ANN ARBOR HISTORIC DISTRICT COMMISSION

Staff Report

ADDRESS: 711 West Jefferson Street, Application Number HDC12-238

APPLICATION: The applicant seeks HDC approval to add a 792 SF two-story rear addition, and a new window on the second floor of the existing house on the east elevation.

Existing
First and Second Floor Plans
Scale: 3/32" = 1'-0" on 8 1/2" x 11" UPDATED 1.18.13

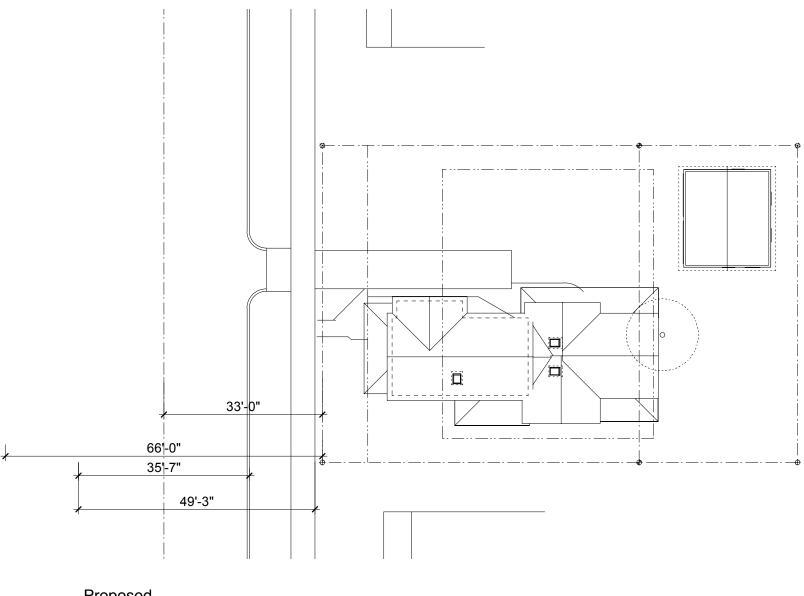
- 1. The bump-out on the westside is gone.
- 2. The overhang on the westside has been reworked, no longer one continuous roof.
- 3. Existing Kitchen window to remain the same.
- 4. Egress windows in existing bedroom to remain the existing, spoke with Ralph Welton, he was okay with no emergency egress window.
- 5. Area increase is now 61% in lieu of the 64%.
- 6. Footprint increase is now 31% in lieu of the 34% we had before.
- 7. New east window in existing wall is now a small awning in lieu of the double hung.
- 8. Errors in window schedule have been revised.
- 9. 20" was removed from the laundry and closet on second floor, on east side to help with reducing the square footage.

Area First Floor sf Existing: 797
New: 280
Total: 1077

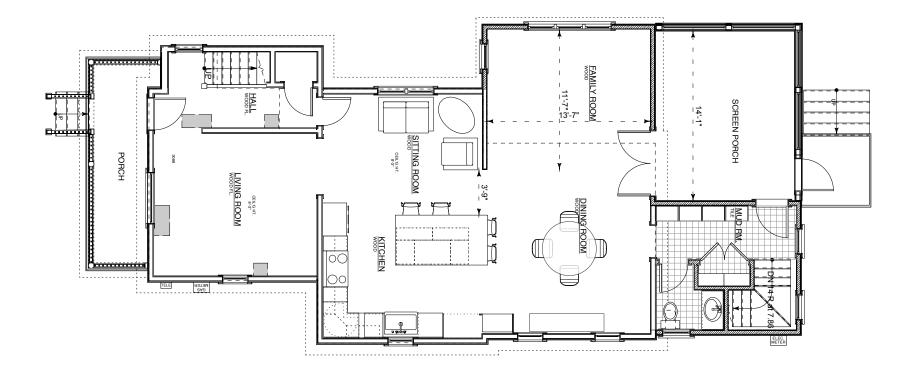
- 2. The proposed two story addition utilizes the existing footprint of the house, and adds an additional 25 feet by 12 foot (for a total of 300SF) to the footprint on the back of the house. The increase in footprint size is 38%. The existing house is 1,293 square feet (SF), and the addition is 792 SF, for a new total of 2,085 SF. The increase in square footage is 61% of the size of the existing house. The square footage of the addition exceeds the *Ann Arbor Historic District Guidelines: Guidelines for All Additions* (see above) by about 146 SF. Note: All of the existing house dates to the period of significance for the district, and therefore counts as "original building" per the *Guidelines* language.

Note since we removed the bump out on the westside, it made the family room not useable, so we traded the family room with the screen in porch and combine the outdoor porch with the left over space to create one usable screen-in porch. This made the most use out of the space and tightened the footprint up.

Proposed
Second Floor Plan
Scale: 3/16" = 1'-0" on 8 1/2" x 11"

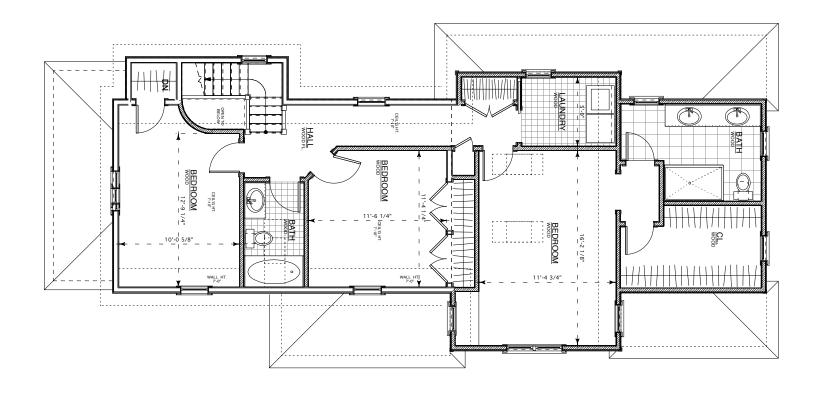
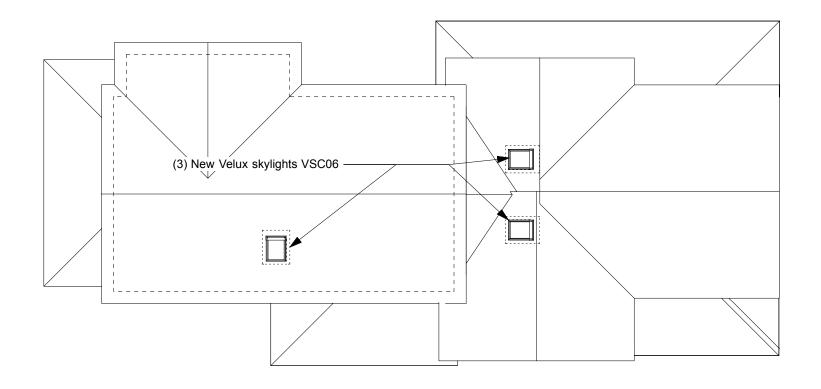
- 4. A new square awning window in a new opening is proposed on the second floor of the original house's east elevation. A new skylight is proposed on the west roof surface of the original house. No original windows are proposed to be replaced.
